CO-Inspection Report No. 50-146/71-03

Subject: Saxton Nuclear Experimental Corporation

License No. DPR-4

CO Report No. 146/70-2

Figure 1

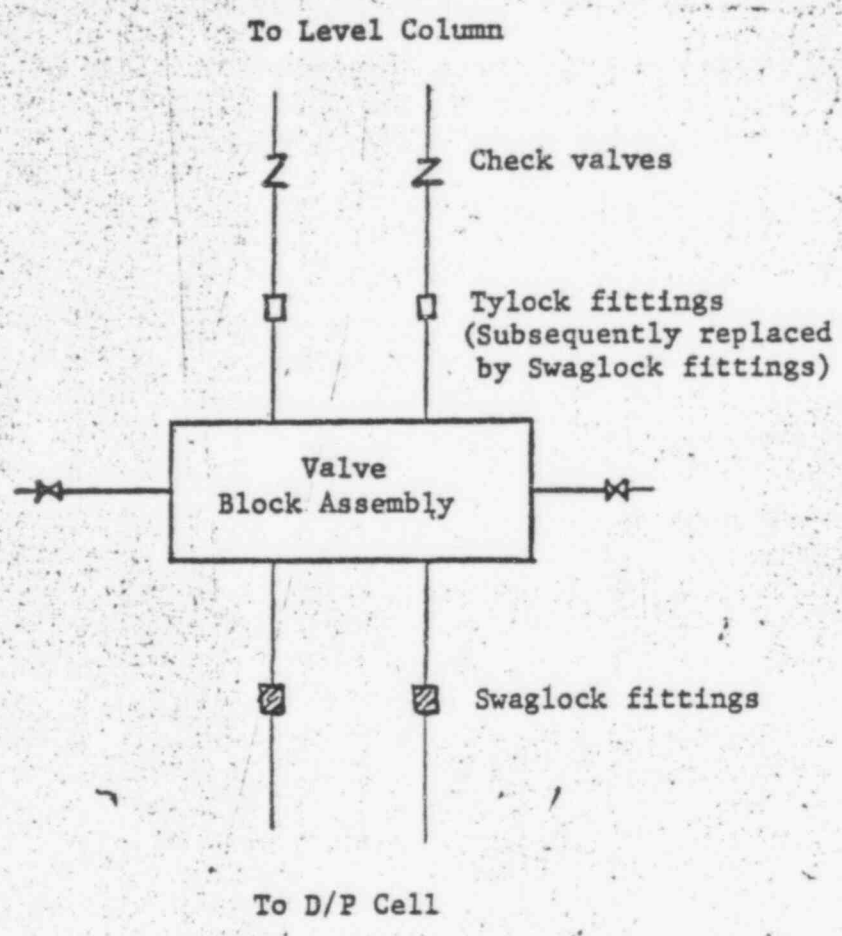
In discussions with Messrs. Swift and Pekar it was learned that the pressurizer channel (LIC-2), which provides signals for continuous level indication, "On" - "Off" high and low level alarms, low-level heater shut-off, and low-level scram, indicated an increase in level from 50% to 100% during primary system heatup (2000 psig and 636° F in pressurizer). The plant was cooled down and investigation revealed that the Tylock fittings in both 3/8 inch stainless steel tubing lines connecting the pressurizer level column to a D/P cell had separated which caused the level indication on LIC-2 to increase to 100%. There was no primary system leakage as a result of this occurrence because the excess flow check valve (Chemiquip Type 50 FM 100) located upstream of the Tylock fitting in both lines, functioned as designed. The separation occurred above the stainless steel

valve block assembly, which is mounted in the D/P cell cabinet. The arrangement is shown in Figure 1 attached. Prior to system heatup the D/P cell had been removed for calibration by uncoupling the D/P cell from the valve block assembly at the Swaglock fittings. Corrective action taken by the licensee consisted of installing a new valve block assembly, replacing the Tylock fittings with Swaglock fittings, recalibrating the D/P cell, and performing a hot functional primary system pressure (leak) test at 2285 psig and 512° F.

Figure 2

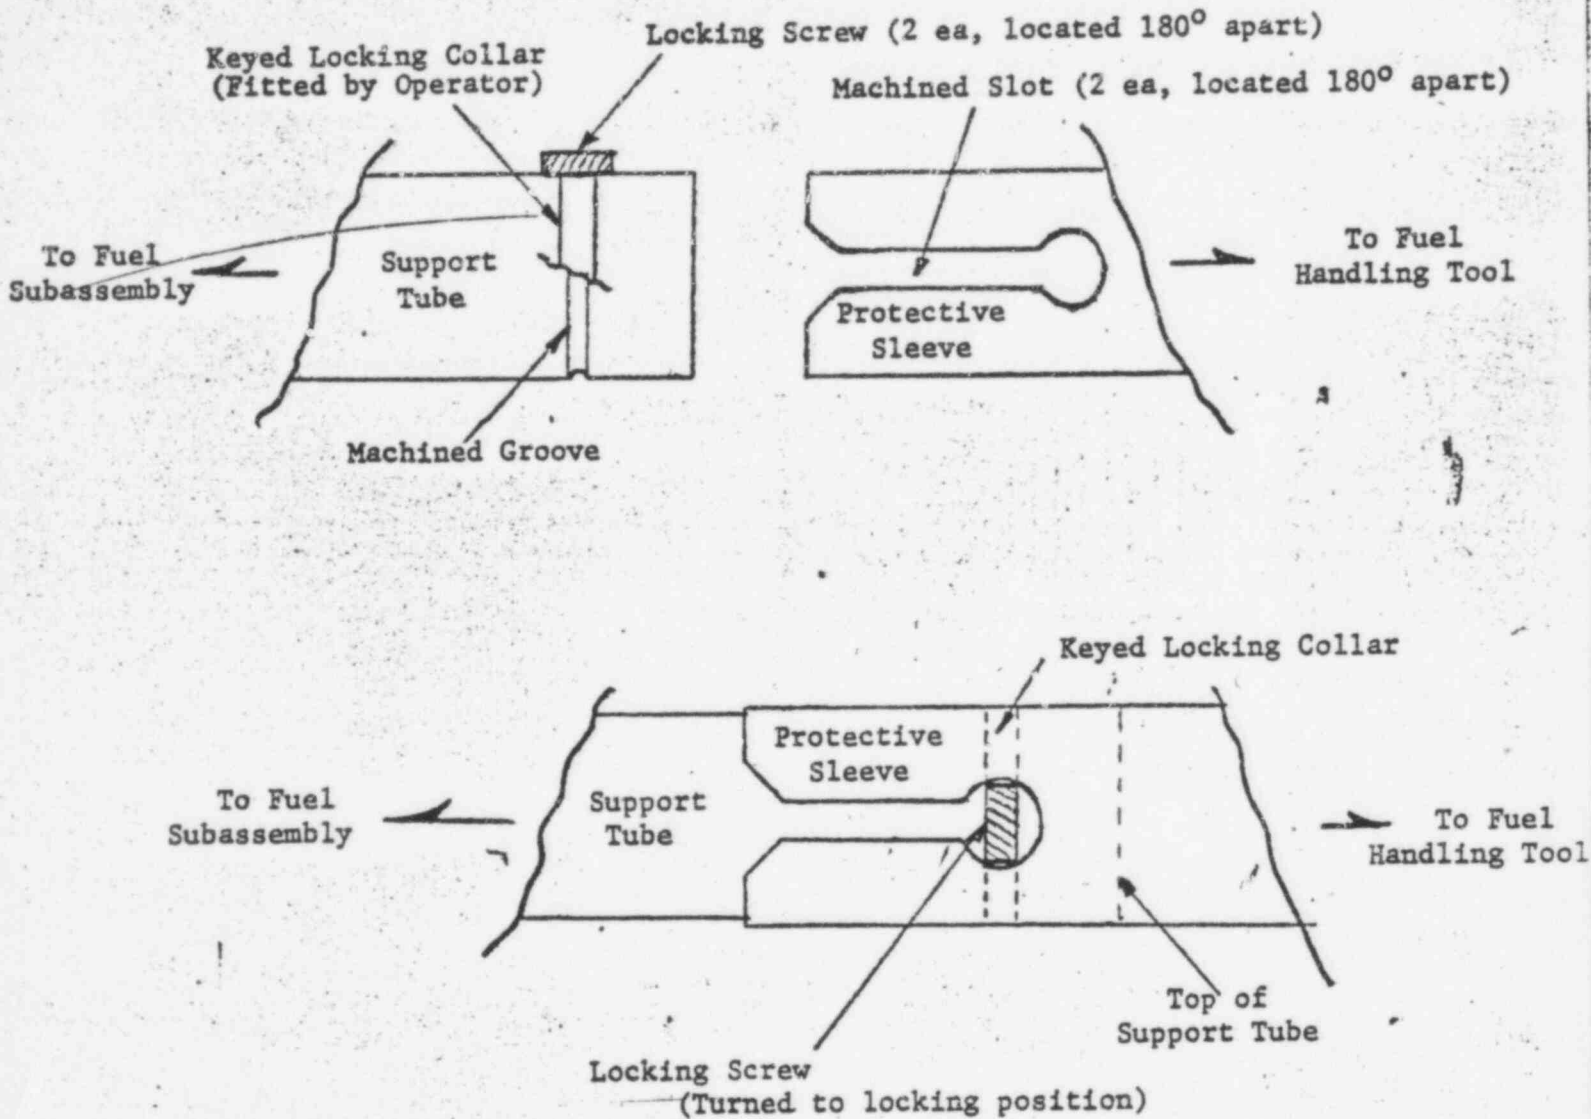
An illustration of the mechanical fitup for lifting a fuel subassembly is given in Figure 2. The locking action occurs when the locking screws are turned 90 degrees by an operator after the protective sleeve is lowered into position over the guide tube. The fitup occurs prior to raising the water level above the top of the reactor pressure vessel head in preparation for fuel handling. Mr. Swift stated that a large force is required to turn the locking screws but in this case the operator noted that less force than normal was required during the fitup. Mr. Swift indicated that both screws apparently rotated during subsequent fuel handling, and that the fuel handling was considerably more than normal due to the inspection of the fuel pins. A review of the draft On-Site Safety Committee minutes for the August 20, 1970 meeting indicated that this occurrence was not reviewed by the committee. This matter was discussed at the exit interview.
